STAFF REPORT ACTION REQUIRED

102 Shuter Street - OPA & Rezoning Application – Supplementary Report on Settlement Offer

Date:	February 16, 2010
То:	Toronto and East York Community Council
From:	Director, Community Planning, Toronto and East York District
Wards:	Ward 27 – Toronto Centre-Rosedale
Reference Number:	08 222718 STE 27 OZ

Attachment 1A: Site Plan – Loading Area

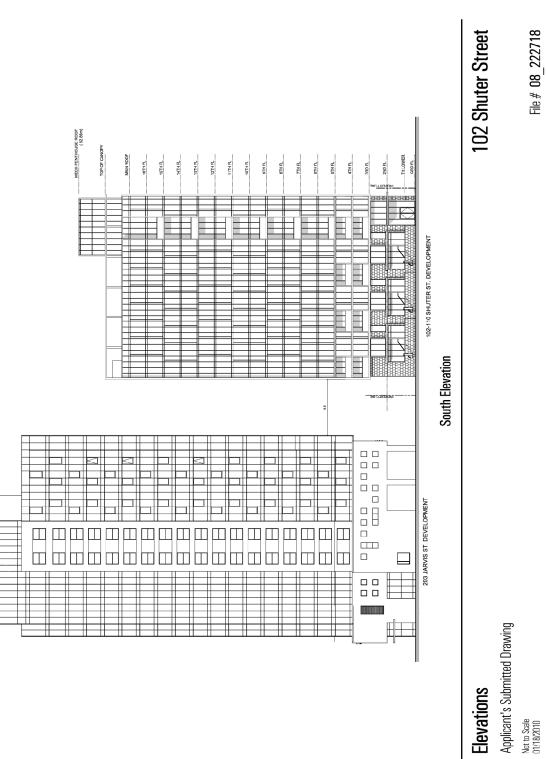
As with the previous proposal, the applicant has provided a valet car holding area and a loading area parallel to one another at the west end of the site accessed from the above mentioned public lane (Attachment 1A). The operation of these two areas conflicts with one another. If the valet holding area is occupied then loading vehicles cannot access the loading area and would obstruct the public lane. Similarly, if a loading truck is parked or exiting this area and vehicles require access to the valet holding area, vehicles may not be able to enter until loading/unloading has been completed. The applicant's current scheme would likely impact the proper operation of the public lane. The public lane is also used for access by residential properties to the north fronting on to both George Street and Jarvis Street. Technical Services and Community Planning require further details as to how this valet/loading area would operate or require the applicant to revise their proposal to address this matter.

Attachment 2C: East Elevation

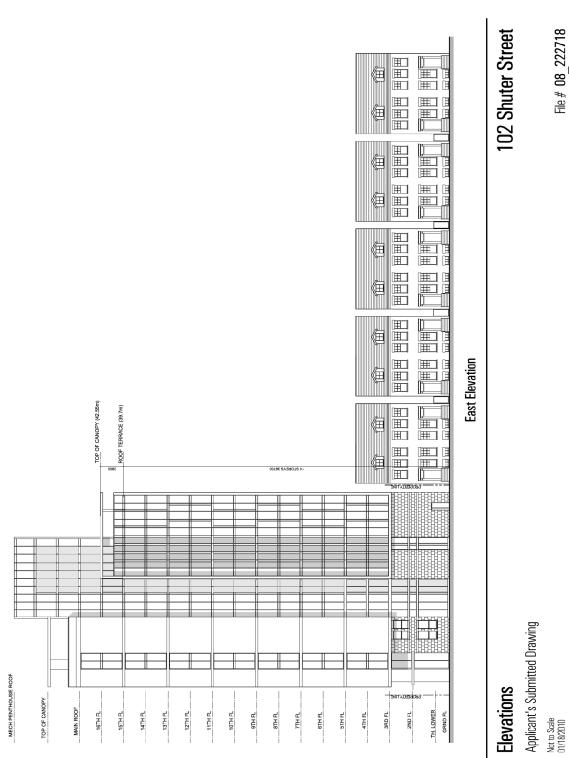
As revised, a situation still exists in which the north end of the proposed residential building at 14-storeys (40 metres) continues to be adjacent to 3-storey (9.6 metre) semidetached homes (Attachment 2C). The setback from the development site to the north property line has increased from 0 metres to 0.8 metres (2.6 feet). The proposed tall building cannot successfully be inserted on a small site abutting a low scale residential neighbourhood.

Attachment 6: Sky view and Shadows

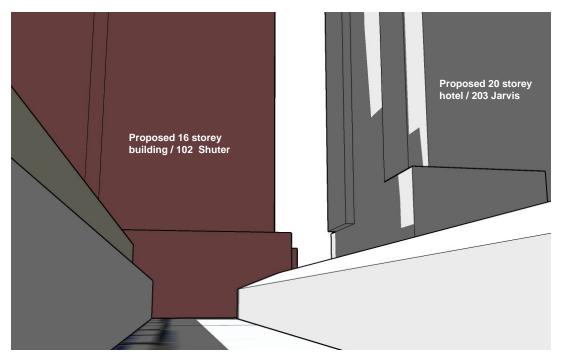
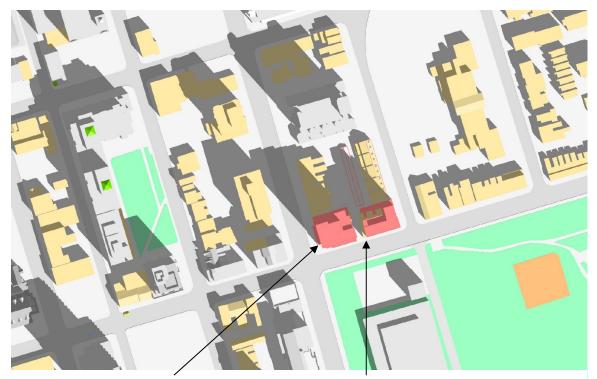
The reduction in floor plate of the tower would not allow for an appropriate separation distance between a tall building at this site and any potential building at 203 Jarvis Street. The property at 203 Jarvis Street is designated Mixed-Use Areas (Attachments 2A & 3). The separation distance has increased from 9.3 metres as opposed to the original proposal of 8 metres, however, the separation is still well below the City of Toronto's 'Design Criteria for Review of Tall Building Proposals' which recommends a minimum building separation distance of 25 metres. Also, having two towers adjacent to one another with such limited spacing, whether the proposed building at 102 Shuter Street is 16 or 20-storeys, would still have a negative impact on sky view from the rear yards of the 10 homes immediately abutting to the north at 226 to 244 George Street (Attachment 6).

The shadowing impacts are more severe in the spring and fall (Attachment 6). Shadowing would begin at approximately 9:00 am in the morning and increase as the morning continues eventually negatively impacting the rear yard amenity areas of all residential properties from 226-244 George Street by about 11:00 am. Those properties closest to the proposed development would remain shadowed longest. Should the proposed development at 203 Jarvis Street, or similar such development be approved, the combination of the two building's shadows would impact those semi-detached homes most of the day with 226-232 George Street shadowed in some form until approximately 4:30 pm.
